The Great Grid Upgrade

Norwich to Tilbury

Design Development Report

AENC-NG-CNS-REP-0005

Figure 5.1 Alignment south of Norwich Main Substation

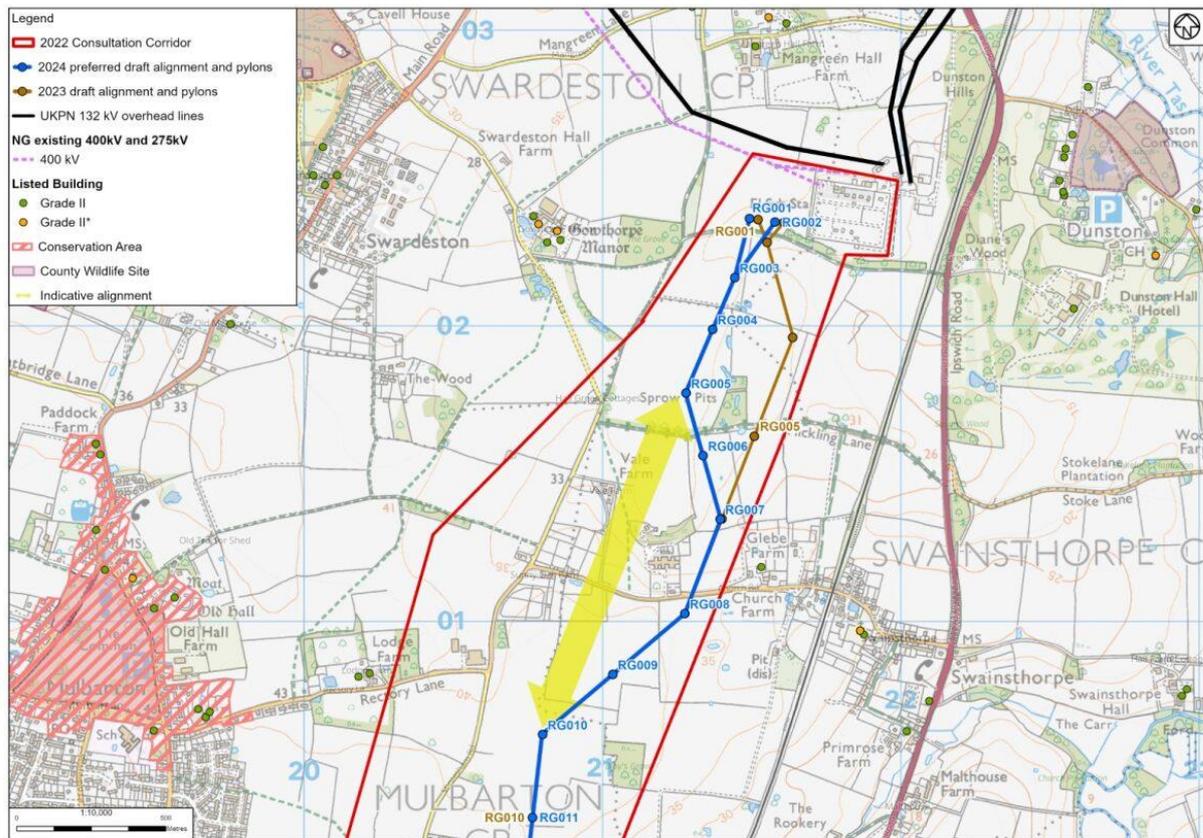
- 5.4.13 This is within Section A which extends from Norwich Main Substation to the River Waveney. Proposals for a battery storage facility have come forward on the south side of Norwich Main Substation which overlap with the 2023 preferred draft alignment in respect of the positioning of pylon RG004 and the span through to RG005 which are close to the existing overhead line (see Figure 5.1).

- 5.4.17 A minor realignment is being taken forward between RG013 to RG017 (referred to as RG12 to RG17 on the 2023 preferred draft alignment). This is in response to the repositioning of RG013 slightly northwards due to the presence of buried archaeological features (identified by surveys for the Bloys Solar Farm), and a consequent realignment of the route to the south, balancing the preference to avoid introducing an additional angle pylon but retaining the position of RG14 to minimise interaction with an existing solar farm.

Figure 5.2 Alignment at Flordon

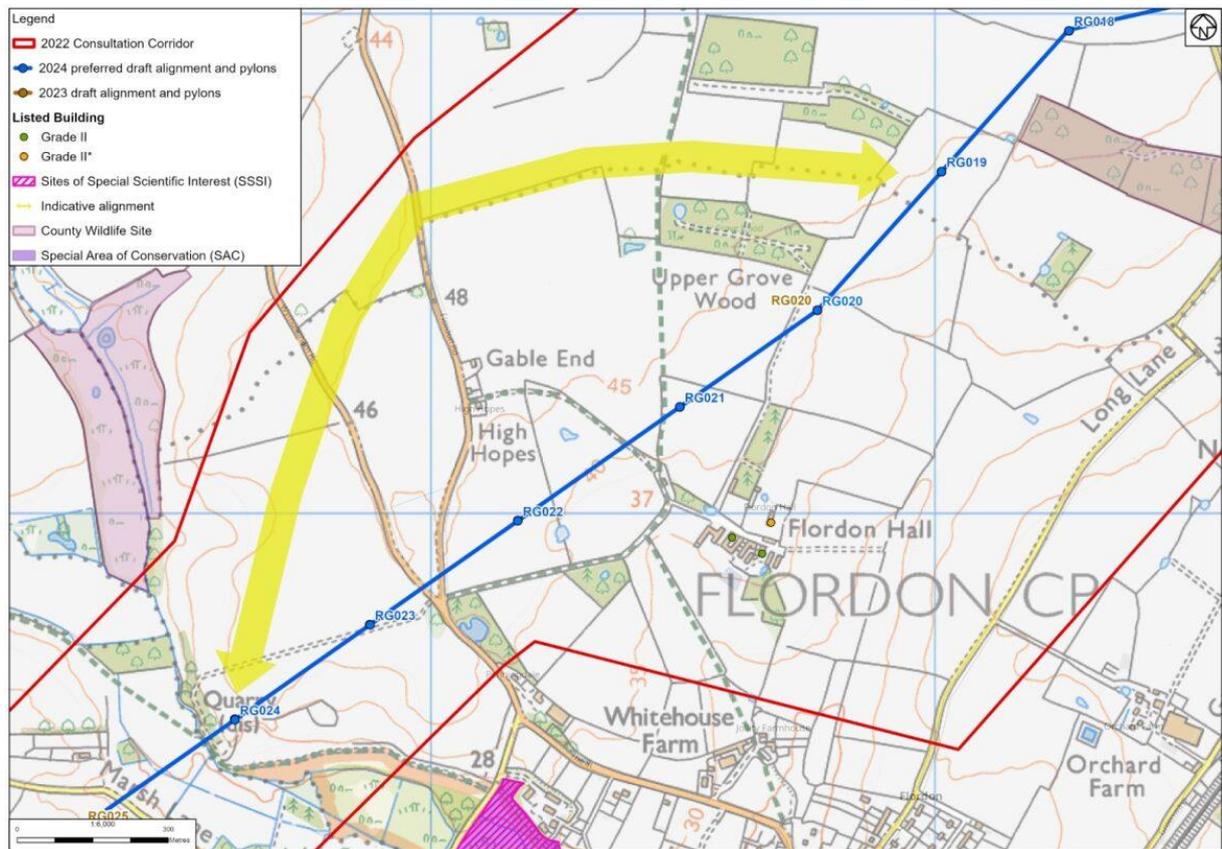
- 5.4.18 Feedback requested moving the route further to the west of Flordon Hall (see Figure 5.2). This would be from around RG019, heading west between blocks of woodland and passing to the west of residential properties at and close to Gable End, before reconnecting in the vicinity of RG024.

- 5.4.19 Whilst this would potentially reduce effects on views from the east of the Grade II* Listed Flordon Hall it would require a longer route, three additional angle pylons and potentially an additional pylon compared with an otherwise substantially straight alignment. It would also partially transfer environmental effects to the Grade II* Listed Mergate Hall and position more pylons in closer views of several homes on Flordon Road. On balance, given the less direct and longer route, and the relative effects of the alternative to other similar receptors, no change is currently proposed, and the preferred alignment is the same as in 2023.

Figure 5.3 Alignment at Tacolneston

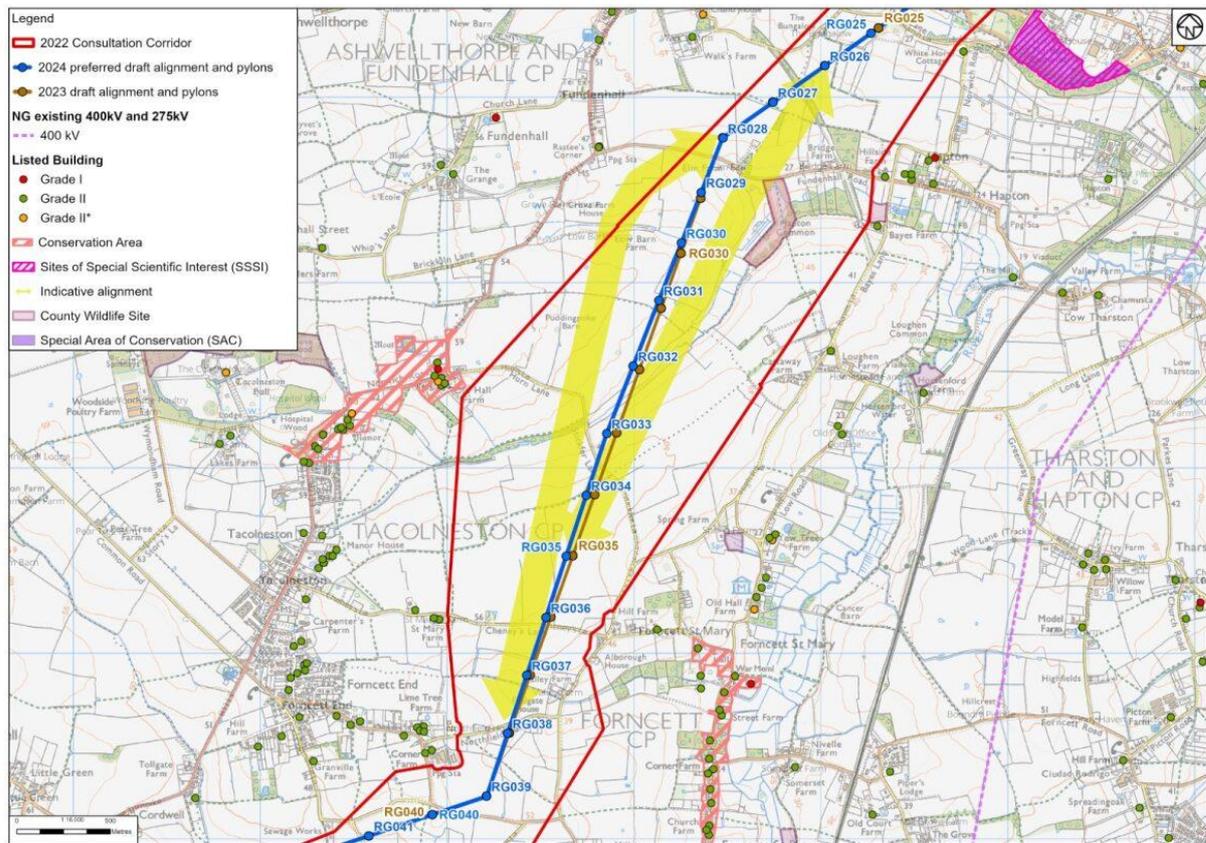
- 5.4.22 Other landowner feedback in this area suggested straightening the 2023 preferred draft alignment between RG024 and RG032 to use a shallow valley to the east. Whilst this would slightly lower the position of the pylons in accordance with some of the Holford Rules, it would reduce consistency with other Rules. It would also, increase effects on residential amenity by passing closer to a greater number of properties, and would lead to some ecological effects on Hapton Common County Wildlife Site (CWS) (as vegetation management would be likely to be required). As such this was less preferred and not taken forward.

- 5.4.20 A slight realignment to the west has been made between RG028 to RG039 (see Figure 5.3) to respond to landowner feedback to position pylons to field boundaries, and to increase separation to South Norfolk Model Flying Club. The feedback requested moving pylons RG028 / RG029 to the west, together with a straight realignment to the south towards RG038. This change would move RG037 much closer to a property where the 2023 preferred draft alignment was approximately midway between it and a property to the east. At this location the nearest pylon to one of the properties also benefits from being positioned behind existing trees to provide some screening.

Figure 5.4 Alignment at Cargate Common

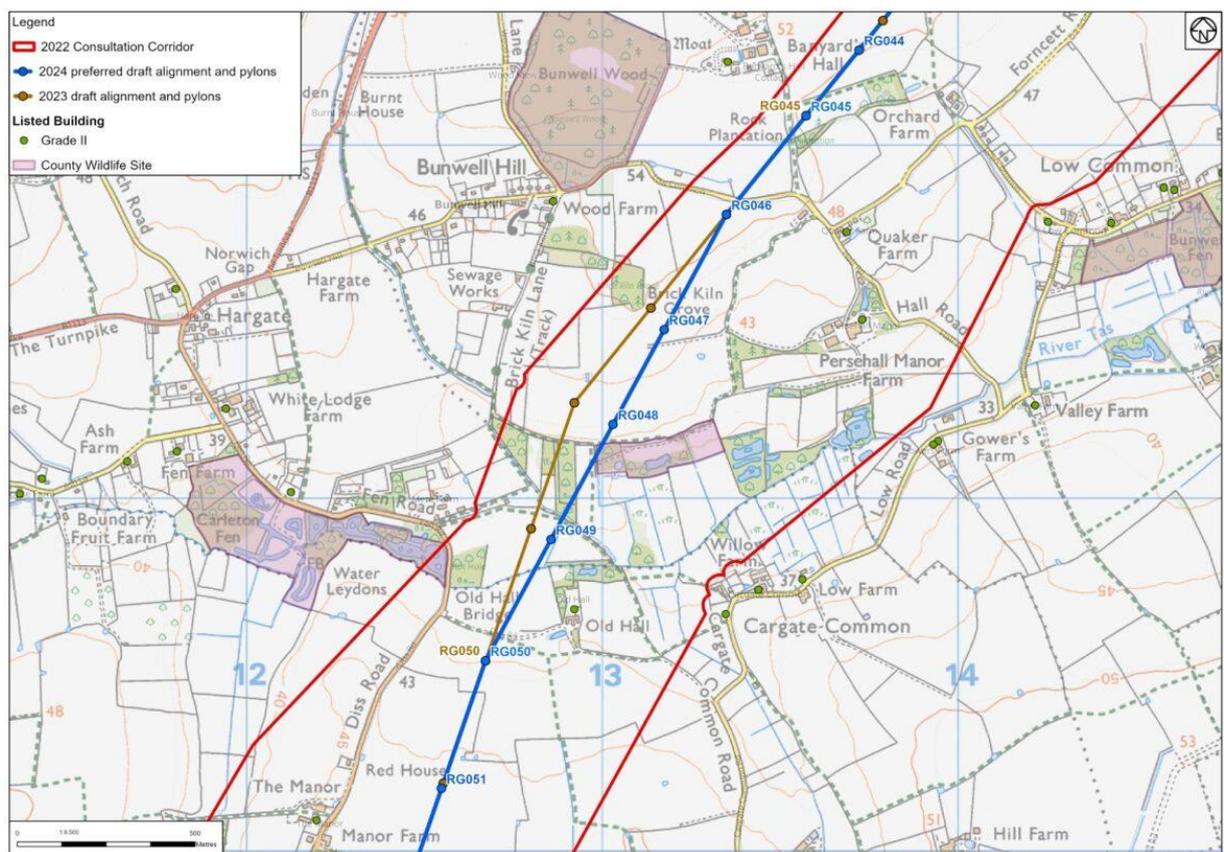
5.4.27 Other feedback in this location suggested alternative alignments should be adopted to the east between RG046 and RG050 (see Figure 5.4) to reduce effects on an area of woodland. An alternative, to divert directly south from the east of RG048 before a right angle turn to reconnect around RG050, was not taken forward due to the greater angle of direction change and potentially increased effects on the residential amenity, and heritage effects at Old Hall. This was change was also considered to be less consistent with the Holford Rules.

5.4.28 The 2024 preferred draft alignment does however include a realignment between RG046 and RG050 which was raised as a further alternative. This replaces a single larger direction change at RG048 with two smaller direction changes at RG046 and RG050. Both the 2023 preferred draft alignment and 2024 preferred draft alignment would affect existing woodland. Although the 2024 preferred draft alignment would oversail the western end of the Brick Kiln Lane Bunwell Hill County Wildlife Site (CWS) on balance ecology effects are considered lower on this alternative than on the 2023 preferred draft alignment and would not be offset by slightly closer routeing (reducing from just over 250 m to just under 250 m) to the Grade II listed heritage asset at Old Hall which benefits from some screening and filtering by existing vegetation.

Figure 5.5 Alignment at Winfarthing

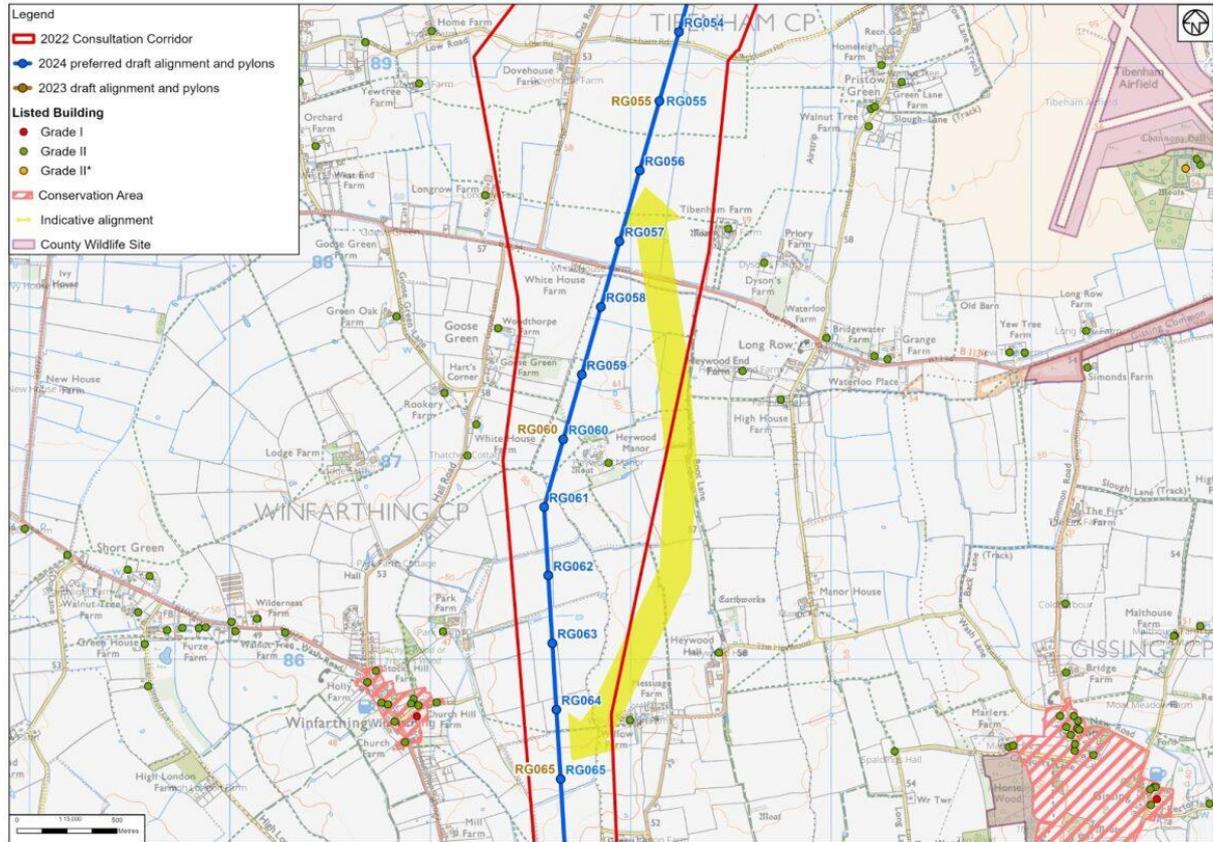
5.4.29 Feedback to position the alignment to the east of Heywood Manor to reduce effects on visual amenity to residents and businesses to the west of RG59 to RG61 has been considered (see Figure 5.5). There is around a 400 m separation between the properties and the 2023 preferred draft alignment. This potential change, without adding undue diversions, would introduce two additional angle pylons and move the alignment closer to properties to the east of Heywood Manor reducing separation to between 250 m and 350 m thus increasing effects on residential amenity. It would also position the overhead

line closer to the southern end of Priory Airfield and likely to restrict flight activity. This alternative is therefore less preferred and has not been taken forward.

Figure 5.6 Alignment at Shelfanger

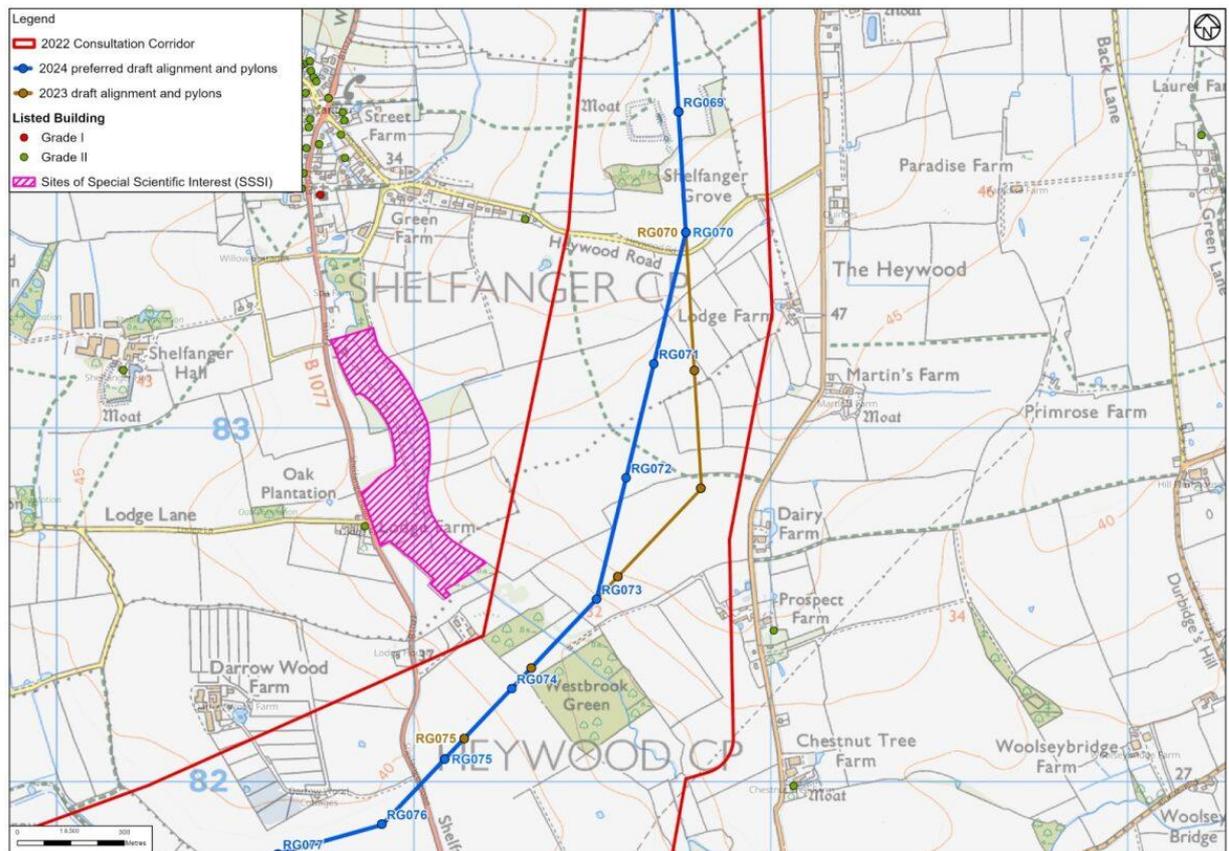
In response to feedback, a small adjustment to the 2023 preferred draft alignment between RG070 and RG073 has been taken forward (see Figure 5.6). Feedback had requested a diversion from RG069, but this has not been taken forward as it would have increased woodland loss (less consistent with the Holford Rules) and increased heritage effects due to oversailing a moat. The change can be made from RG070, requiring one angle pylon with a larger direction change to be replaced with two pylons each with a relatively smaller angle change. This reduces effects on residential amenity by increasing separation between the alignment and a number of homes to the east (including Lodge Farm and Dairy Farm) with the separation from the closest property increasing from around 150 m to around 300 m. For properties to the west, there is a slight reduction in separation, but this remains in excess of 400 m from the closest property. This change also allows for the adjustment of the position of RG074, moving it out of an ecologically more valuable river valley (from a field around 300 m from Shelfanger Meadows, just upstream in the valley) into an arable field.

Figure 5.7 Alignment at Diss

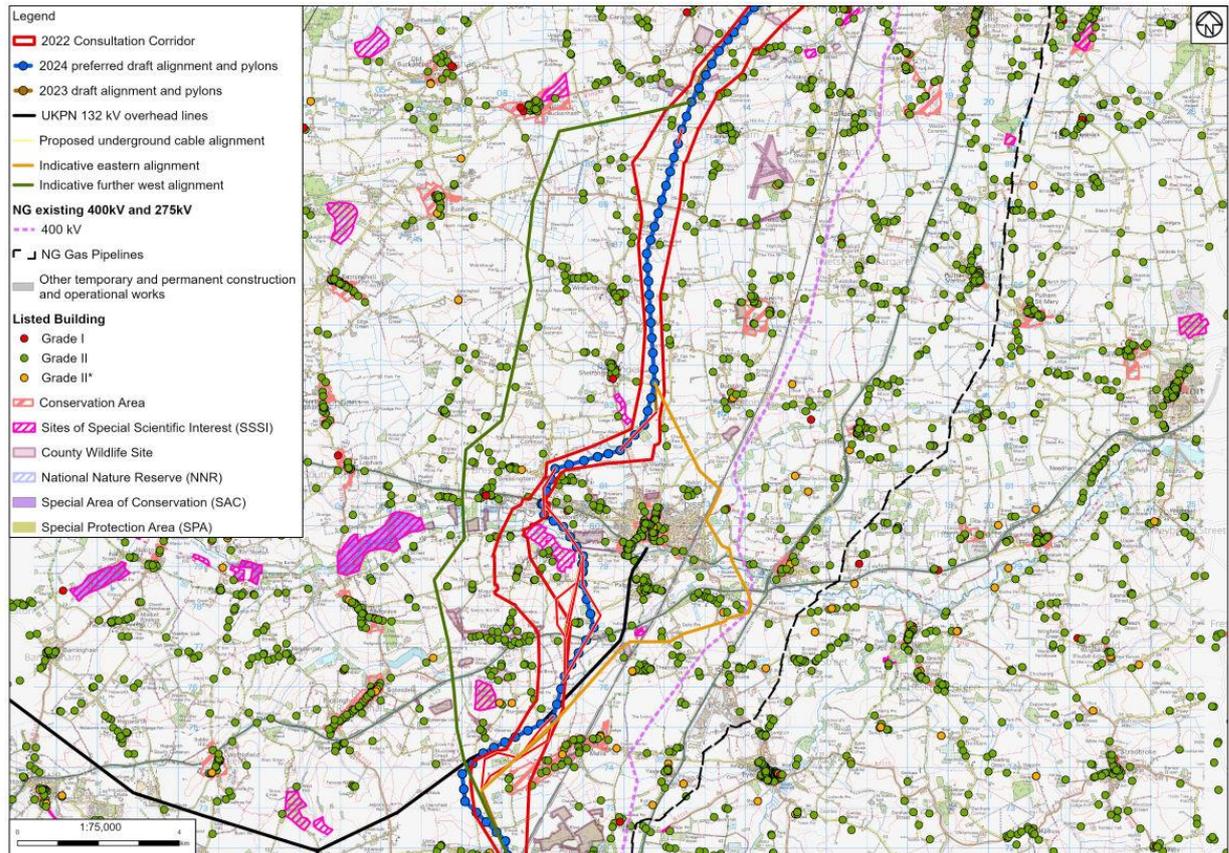
- 5.4.31 The River Waveney forms the boundary between sections with section A to the north and section B to the south. Potential alternative alignments to pass further to the west of Diss, than the 2023 preferred draft alignment, as well as potential alternative alignments to pass to the east of Diss have been backchecked in response to restated preferences in feedback responses (see Figure 5.7).

- 5.4.33 Alternatives further west as overhead line only are overall considered less preferred because they would lead to greater effects. For an overhead only alternative. A Grade I Listed Church (Church of St John the Baptist at Bressingham) would be passed at similar ground level around 550 m to the west (the 2023 preferred draft alignment passes a Grade I listed church on lower ground at around 400 m distance). Ecological effects are considered to be greater than for the 2023 preferred draft alignment due to closer proximity (approximately 1 km compared with approximately 3 km for the 2023 preferred draft alignment) to Redgrave and Lopham Fens (SSSI, Ramsar, National Nature Reserve, Special Area of Conservation). It would also route is through an area more central to nature recovery proposals that are being progressed.

Figure 5.8 Alignment for Waveney Valley Alternative

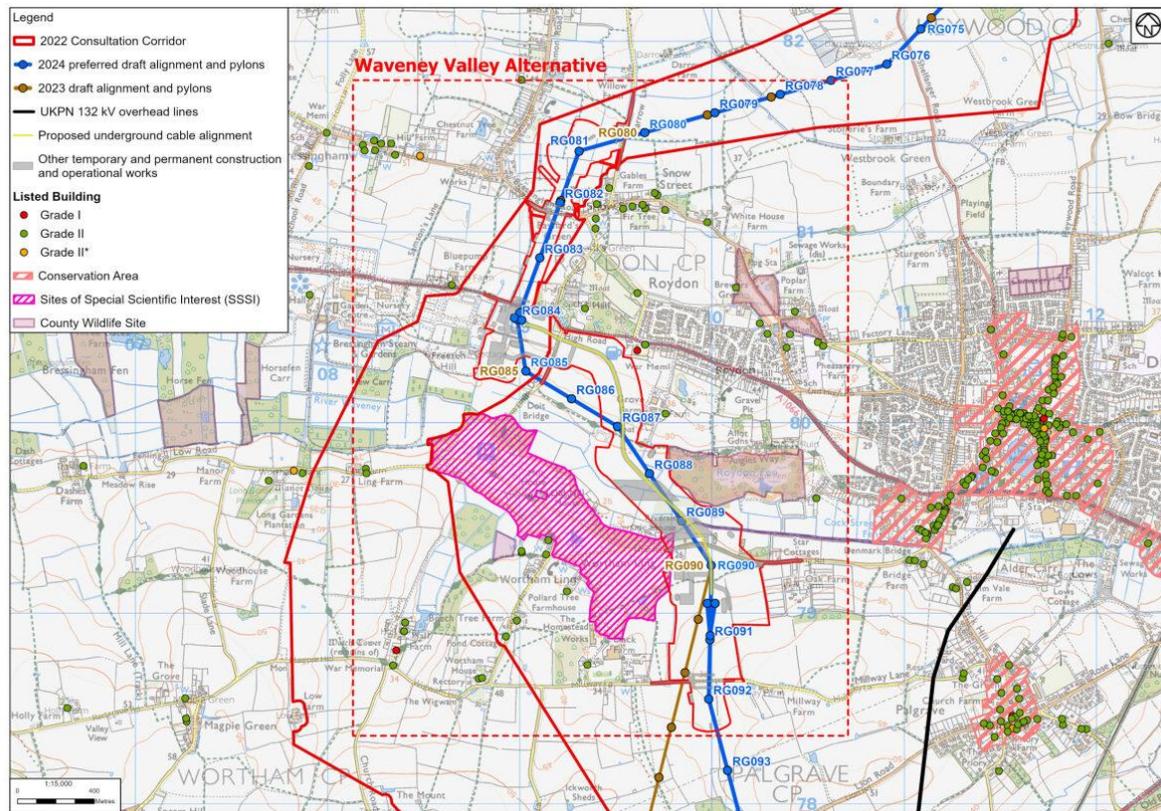
- 5.4.52 In considering whether the threshold implied by paragraph 2.9.23 is met, National Grid has developed a proposed arrangement, referred to as the Waveney Valley Alternative, for a connection incorporating some underground cable (see Figure 5.8). This shows both the alignment and pylon positions if progressed as overhead line along with the route of the underground cable in the Waveney Valley Alternative arrangement. In this alternative arrangement, which is proposed to comprise of an approximately 2 km section of underground cable with CSE compounds adjacent to RG84 (just to the south of the A1066) and to the north of RG91.

- 5.4.54 There would be potential benefits of a section of underground cable in terms of landscape effects. A limited number of residential properties would also benefit from reduced effects on residential amenity in views from a small number of properties along the A1066 with views to the south over the valley.
